## Planning Sub-Committee – 08/05/2024

<b>ADDRESS:</b> 53 Northchurch Road, Hackney, London, N1 4EE	
<b>WARD:</b> De Beauvoir	<b>REPORT AUTHOR:</b> James Clark
<b>APPLICATION NUMBERS:</b> 2023/0971 (planning application) and 2023/0973 (listed building consent application)	<b>VALID DATE:</b> 27-04-2023
<b>DRAWING NUMBERS:</b> 384 TP 601 Rev2; 384 TP 602 Rev2; 384 TP 603 Rev2; 384 TP 604 Rev2; 384 TP 605 Rev2; 384 TP 001; 384 TP 010; 384 TP 100; 384 TP 201; 384 TP 211; 384 TP 111	
<b>APPLICANT:</b> Vicki and Stephen Chapman/Grosz	<b>AGENT:</b> Bernard Tulkens (Tectonics architects ltd)
<b>PROPOSAL:</b> Installation of Photovoltaic panels on the rear and side roof slopes.	
<b>POST SUBMISSION REVISIONS:</b> N/A	
<b>RECOMMENDATION SUMMARY:</b> Refuse planning permission and listed building consent.	
<b>NOTE TO MEMBERS:</b> This application is referred to members of the Planning Sub-Committee for consideration at the request of 11 Councillors.

### CASE OFFICER'S REPORT

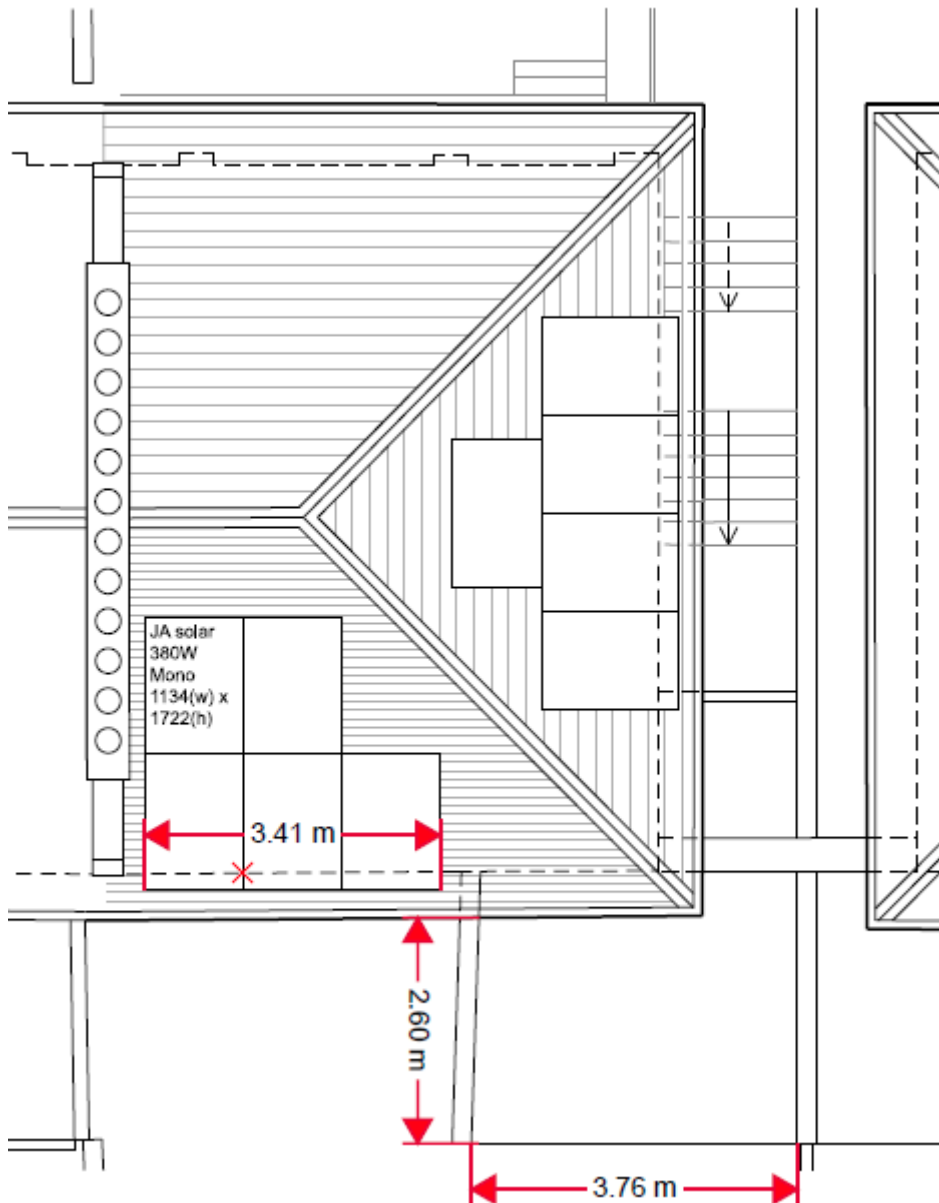
- 2.12 As previously set out in the December 2023 Planning Committee report, Officers are of the view that the location of the solar panels, particularly on the east side elevation, are visually intrusive and harmful to the special interest of the listed building and character and appearance of the conservation area. As outlined in the December sub-committee report, the application site forms part of a row of handsome Italianate stuccoed semi-detached villas built during the early 1840s within the De Beauvoir Conservation Area. These Villas are noted in the conservation area appraisal document for their coherence and homogeneity.

- 2.13 The proposed panels would stand proud off the roofscape by 15cm, while their framing and smooth, reflective surface would make them stand out as modern, incongruous additions to the traditional roofscape of the listed building. Furthermore the large area of solar panels would partially obscure the historic roof slates of the roof representing a reduction in the quality of materials and uniformity of the group. The proposal is therefore considered to form a visually distracting and harmful addition to the historic character of the building.

- 2.14 In the case of this statutory listed building, the installation of PV panels to the side and rear elevation is considered to result in an uncharacteristic, incongruous and unsympathetic form of development, which will result in harm to the architectural and historic interest of the host building, significance of the pair of semi-detached villas, the overall group value of neighbouring properties and the wider De Beauvoir Conservation Area. These roof slopes remain largely unaltered and therefore any alteration needs to be considered sensitively. The proposed solar panels would be viewable from both Northchurch Road to the front of the site and Deacon Mews to the rear. The visibility of the panels would be increased by their projection from the roof slope and the smooth reflective surface of the solar panels. As with all Listed

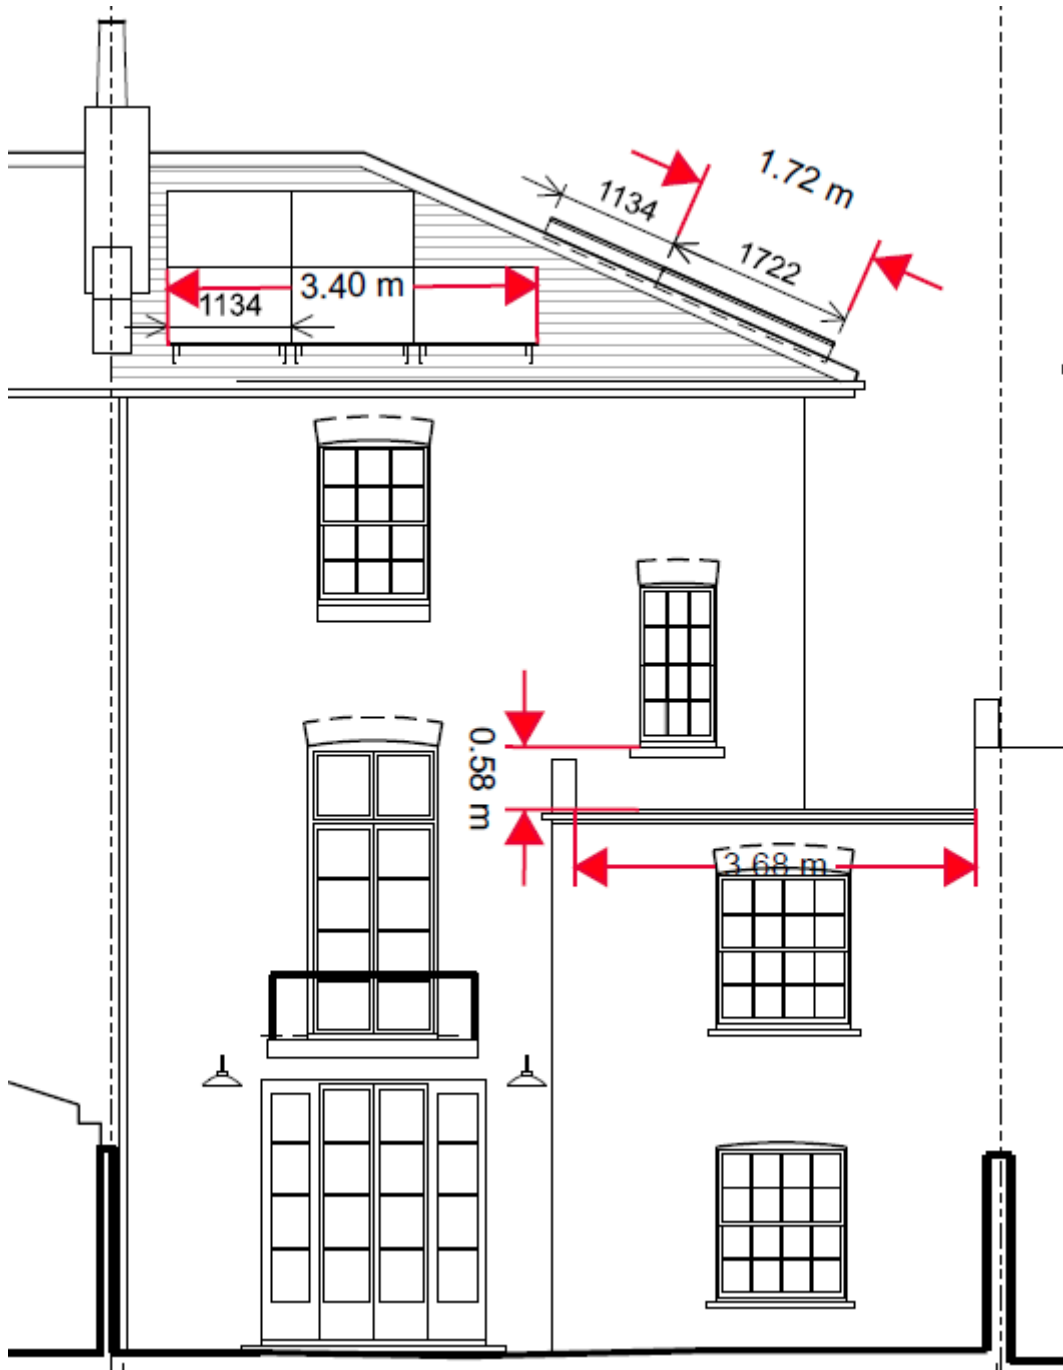
- 2.17 As part of the discussions relating to the retrofit plan, officers advised that solar panels could be located on the rear outrigger and main roofslope. This was considered to be a less visually prominent location where the position of the solar panels would result in a lower level of harm to the significance of the heritage building as the views from the front are of higher significance. Analysis of the submitted drawings would suggest that at least 3 PV panels could be installed on the south facing outrigger, based on the figures provided by the applicant, this would have the potential to generate 1,440 kWh/yr (3x 480 kWh) which combined with the 5 PV panels on the main roof rear slope will provide an overall on site generation of 3,840 kWh/yr which will exceed the household yearly electricity consumption of 3,578 kWh/yr. The excess of electricity generated can be sold to the National Grid through appropriate schemes or stored in the on-site battery for future use.

- 2.18 Following Officers recommendation to amend the Solar PV layout, the applicant confirmed they were unwilling to make the suggested alterations, citing that only 2 solar panels could be installed on the outrigger roof, without prejudicing living conditions through overshadowing. Officers disagree this claim, due to a variety of factors, such as the availability of space on the outrigger roof (see layout plan below), distance in height between the outrigger roof and window (see elevation below), the trajectory of the sun (full south orientation) and that the window serves a hallway, a non habitable space with no light requirements under BRE guidance. In the event that the applicant can robustly demonstrate that only 2 panels can be fitted, the overall on site electricity generation would reach 3,360 kWh/yr (2x 480

kWh + 2,400 kWh), leaving 218 kWh/yr to be sourced from the national grid (3,578 kWh - 3,360 kWh), which can reasonably be considered as a solid improvement in decarbonising the premise (94% of the energy)
